WELL API NO. 30-025-43023
5. Indicate Type of Lease STATE <input type="checkbox"/> FEE <input checked="" type="checkbox"/>
6. State Oil & Gas Lease No.
7. Lease Name or Unit Agreement Name Fascinator Fee Com
8. Well Number #2H
9. OGRID Number 229137
10. Pool name or Wildcat WC-025 G-09 S243532M; Wolfbone

SUNDRY NOTICES AND REPORTS ON WELLS (DO NOT USE THIS FORM FOR PROPOSALS TO DRILL OR TO DEEPEN OR PLUG BACK TO A DIFFERENT RESERVOIR. USE "APPLICATION FOR PERMIT" (FORM C-101) FOR SUCH PROPOSALS.)	
1. Type of Well: Oil Well <input checked="" type="checkbox"/> Gas Well <input type="checkbox"/> Other <input type="checkbox"/>	
2. Name of Operator COG Operating, LLC	
3. Address of Operator 2208 W. Main Street Artesia, NM 88210	
4. Well Location Unit Letter O : 210 feet from the S line and 1980 feet from the E line Section 30 Township 24S Range 35E NMPM County Lea	
11. Elevation (Show whether DR, RKB, RT, GR, etc.) 3318' GR

CONDITIONS FOR PLUGGING AND ABANDONMENT

PROPOSED WELL SKETCH

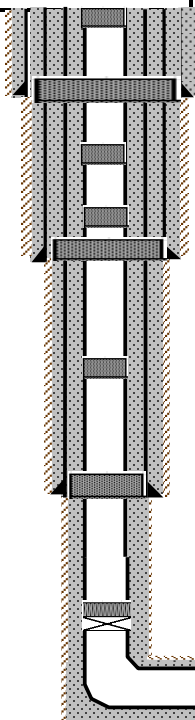
Run CBL If log show good bond perfs are not needed

SEE ATTACHED COA's

Must be plugged by 6/1/24

- Set 5 1/2 CIBP @ 12,050'. Circ hole w/ MLF. Pressure test csg. Spot 25 sx cmt @ 12,050-11,950'.
- Perf & Sqz 50 sx cmt @ 9765-9565'. WOC & Tag (7 5/8" Shoe) Spot 25 sx cl H cmt 9325' - 9125' - T BS
- Spot 25 sx cmt @ 6480-6280'. (Cherry) Spot 25 sx cl H cmt 8035' - 7835' - T Brushy
- Perf & Sqz 50 sx cmt @ 5507-5300'. WOC & Tag (10 3/4" Shoe)
- Spot 25 sx cmt @ 5175-4875'. WOC & Tag (B/Salt)
- Spot 25 sx cmt @ 1275-1075'. WOC & Tag (T/Salt)
- Perf & Sqz 50 sx cmt @ 1000-800'. WOC & Tag (16" Shoe)
- Spot 25 sx cmt @ 200' to surface.
- Cut off well head, verify cmt @ surface, weld on Dry Hole Marker.
